Department of Energy

The purpose of this letter is to respond to your February 6, 2003 letter concerning issues related to proper sealing and inerting of Multi-Canister Overpacks (MCO) at the Hanford Spent Nuclear Fuel Project. The attached report from the Hanford Site addresses your concerns on the following:

SUBJECT: HANFORD SPENT NUCLEAR FUEL (SNF) PROJECT MULTI-CANISTER
OVERPACK (MCO) WELDING

ATTACHMENT 2
Relaxation of the MCO Shield Plug Gasket
Due to Lifting and Handling at the CSB

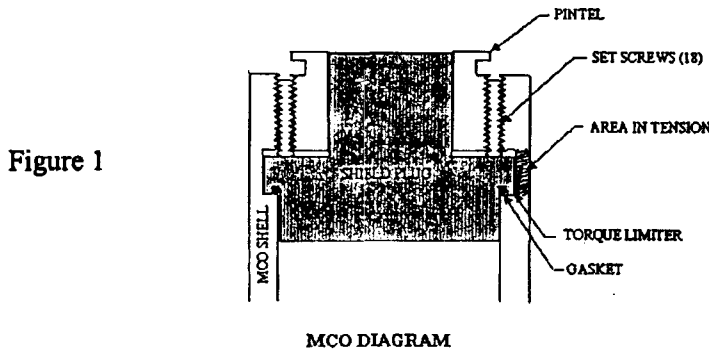
During closure, a shield plug is pressed into the MCO with 150,000 lbs of force by a hydraulic ram to crush the gasket and make a seal. The torque limiter limits gasket compression to the prescribed amount. The shield plug is held in place by 18 set screws, which maintain the preload on the gasket after the ram is removed. The top of the MCO contains a pintel by which it is lifted. The pintel is part of the locking ring, which is attached to the MCO shell by a buttress thread, and forms a single component for this stress analysis. This threaded joint is not shown for clarity. See Figure 1 for a schematic representation.

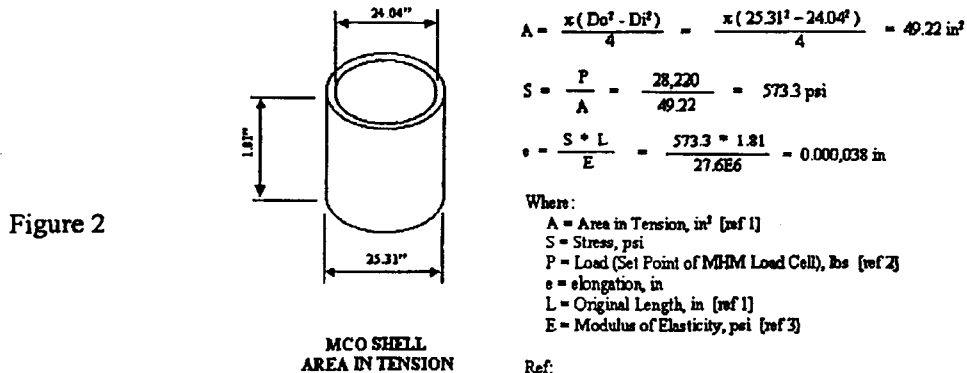
A loaded MCO weighs approximately 20,000 lbs, but the safety class Load Cell Verification System (LCV) high limit in the MCO Handling Machine (MHM) is 25,797 lbs and the high-high limit is 28,220 lbs. Assuming an MCO became stuck in a CSB tube and the first LCV limit failed, pulling on an MCO's pintel would stretch the MCO wall at the area in tension by approximately 38 millionths of an inch, as shown in Figure 2.

Because the shield plug is in compression it will expand by some amount, as determined by the relative ratio of the MCO wall area to shield plug compression area, and the amount of compression in the gasket. In the best-case scenario, the shield plug would expand by 38 millionths of an inch also, so the gasket compression would not relax. In the worst-case scenario the shield plug would not expand at all and the gasket compression would relax by 38 millionths of an inch. Based on an evaluation of the Helicoflex seal (gasket), it is estimated that it would take approximately .005 inches of relaxation to affect the sealing capability. Therefore, the effect on sealing is insignificant.
